**RFT# 4233 - Addendum #1  
Window & Cladding Replacement  
Alderney Elementary**

**The bid documents shall be amended, and new drawings and clauses added, and shall become part of the contract documents as follows:**

SCALE:	AS NOTED
DRAWN BY:	STAFF
REVIEWED BY:	
DATE:	MAY, 2024
PROJECT TITLE	ALDERNEY ELEMENTARY WINDOW AND CLADDING REPLACEMENT
Project Number	
SHEET TITLE	ELECTRICAL ELEVATIONS AND SPECIFICATIONS

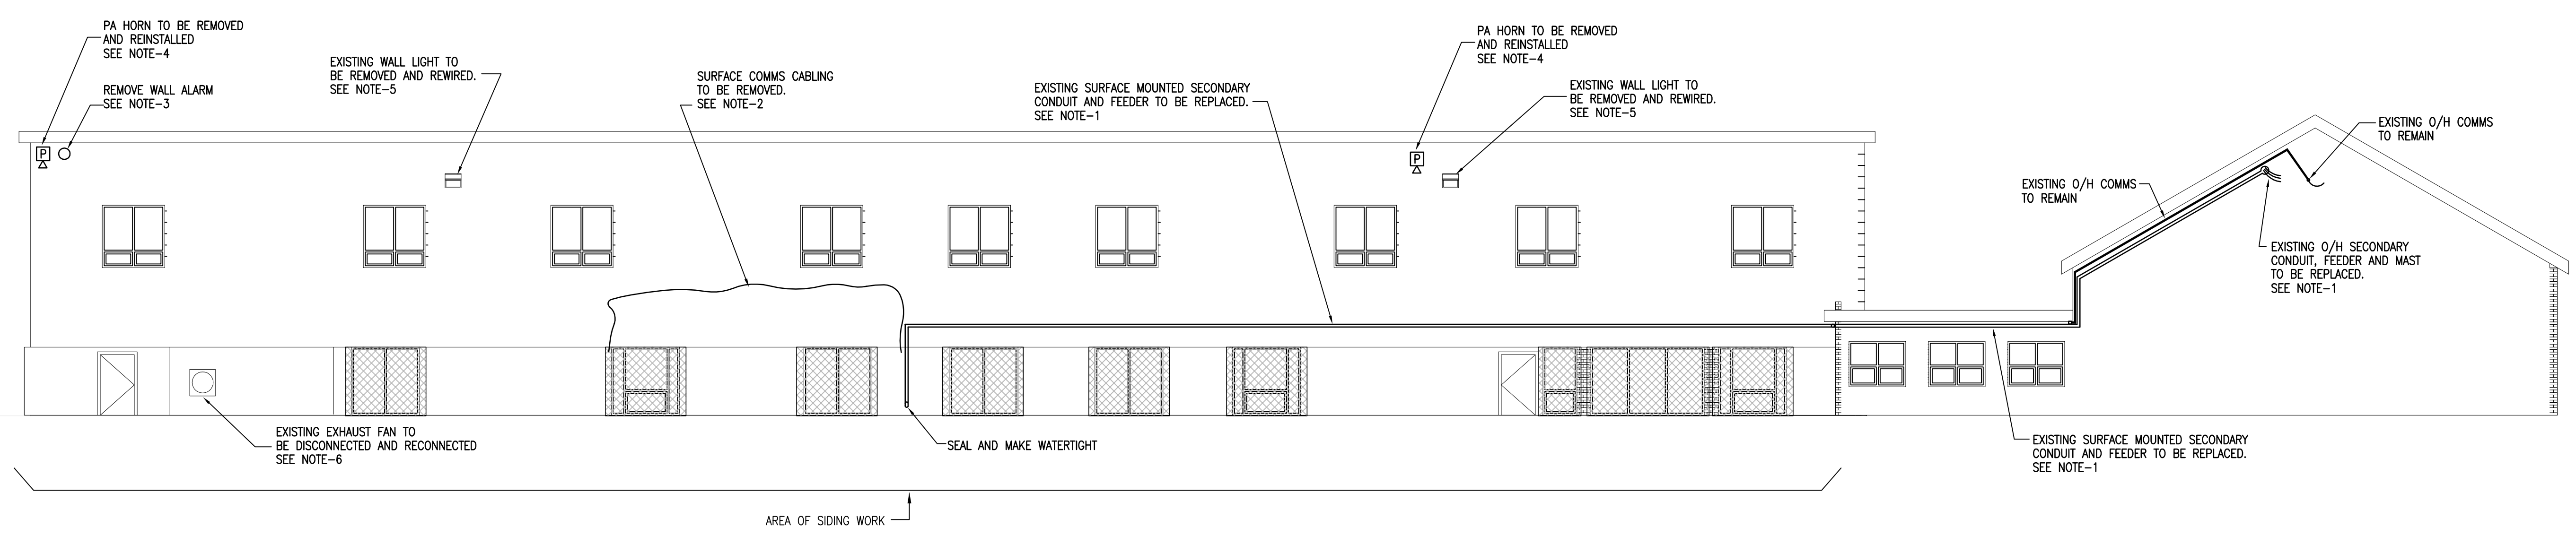
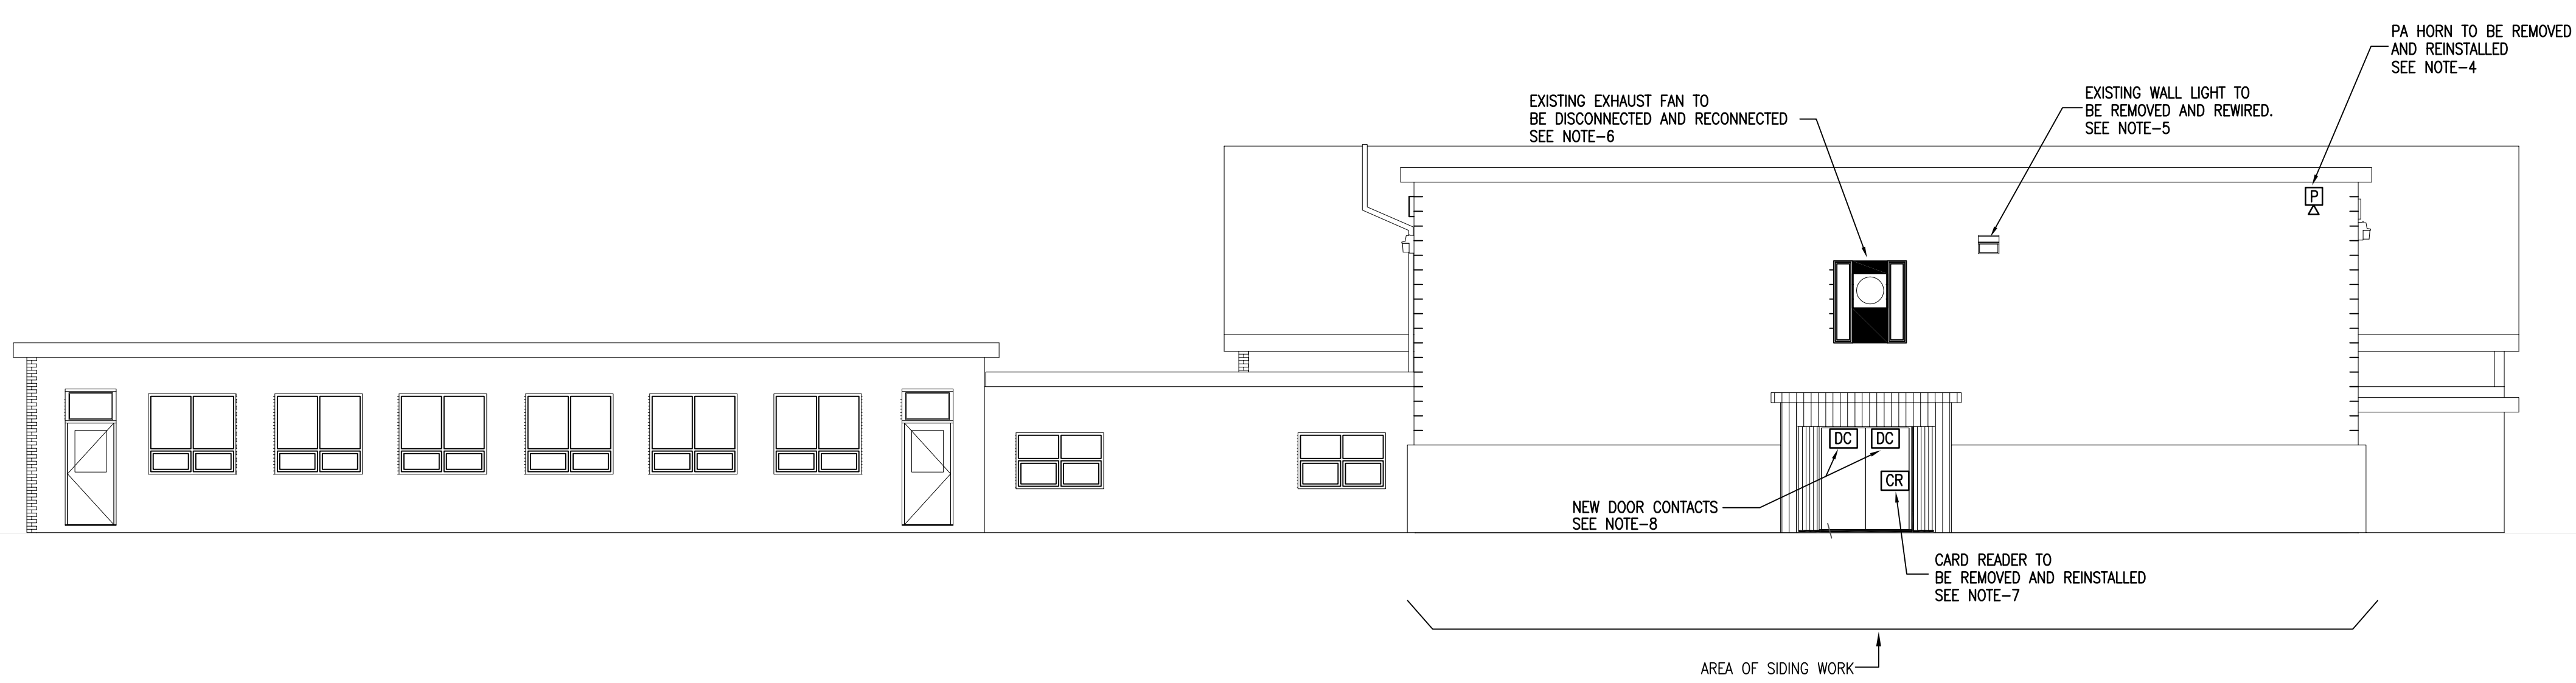
- NOTE-1:**  
EXISTING OVERHEAD SECONDARY SERVICE, MAST AND ALL SURFACE MOUNTED CONDUIT AND ASSOCIATED FITTINGS TO BE DISCONNECTED, REMOVED, REPLACED WITH NEW RIGID PVC CONDUIT AND MAST, PROVIDE NEW RW90 COPPER SECONDARY FEEDER SIZED TO SUIT CEC REQUIREMENTS. VERIFY MOUNTING LOCATION OF NEW SERVICE MAST AND SECONDARY CONDUIT ROUTING WITH N.S.P. PRIOR TO ROUGH-IN. ELECTRICAL CONTRACTOR TO LIASE WITH NSP AND COORDINATE ALL POWER INTERRUPTIONS WITH OWNER. ALL N.S.P. COSTS ASSOCIATED WITH SERVICE REPLACEMENT SHALL BE BY OWNER. VERIFY ALL EXISTING EQUIPMENT ON SITE PRIOR TO CLOSE OF TENDER.

- NOTE-2:**  
EXISTING SURFACE COMMS CABLING TO BE DISCONNECTED AND REMOVED. VERIFY REDUNDANCY WITH OWNER PRIOR TO REMOVING.
- NOTE-3:**  
EXISTING SURFACE WALL ALARM TO BE DISCONNECTED AND REMOVED. VERIFY REDUNDANCY WITH OWNER PRIOR TO REMOVING.

- NOTE-4:**  
EXISTING EXTERIOR PUBLIC ADDRESS HORN TO BE DISCONNECTED AND REMOVED BY ELECTRICAL CONTRACTOR. HRCE TO RE-INSTALL HORN AND RE-TERMINATE. ELECTRICAL CONTRACTOR TO EXTEND EXISTING CIRCUITRY AS REQUIRED.

- NOTE-5:**  
EXISTING EXTERIOR WALL LED FIXTURE TO BE DISCONNECTED, REMOVED, REINSTALLED AND REWIRED. REMOVE ALL EXPOSED SURFACE CONDUIT, BOXES AND WIRE. PROVIDE FIXTURE BACK BOX AND RUN 20#12 TECK 90 BEHIND NEW WALL CLADDING TO SUITABLE SIZED FIXTURE BACKBOX. REFER TO DRAWING E-101.

- NOTE-6:**  
EXISTING EXTERIOR WALL EXHAUST FAN TO BE REMOVED AND REINSTALLED BY MECH CONTRACTOR. ELECTRICAL CONTRACTOR TO DISCONNECT AND RECONNECT FAN. EXTEND CIRCUITRY AS REQUIRED.

- NOTE-7:**  
EXISTING DOOR ACCESS CONTROL SYSTEM CARD SWIPE TO BE DISCONNECTED, REMOVED, REINSTALLED AND RECONNECTED BY HRCE TO ACCOMODATE NEW SIDING AND NEW DOOR INSTALLATION. ELECTRICAL CONTRACTOR TO PROVIDE ACCESS CONTROL WIRING ROUGH-IN FOR NEW DOOR SYSTEM AS REQUIRED. COORDINATE WITH HRCE.

- NOTE-8:**  
DOORS ARE BEING REPLACED BY GENERAL CONTRACTOR. DISCONNECT AND REMOVE ANY EXISTING REDUNDANT INTRUSION DETECTION SYSTEM DOOR CONTACTS. SUPPLY AND INSTALL NEW DOOR CONTACTS AS INDICATED ON PLAN. WIRE TO EXISTING INTRUSION ALARM SYSTEM. REUSE EXISTING WIRING WHERE POSSIBLE. EXTEND CIRCUITRY AS REQUIRED. FINAL TERMINATIONS AT PANEL AND PROGRAMMING BY HRCE.
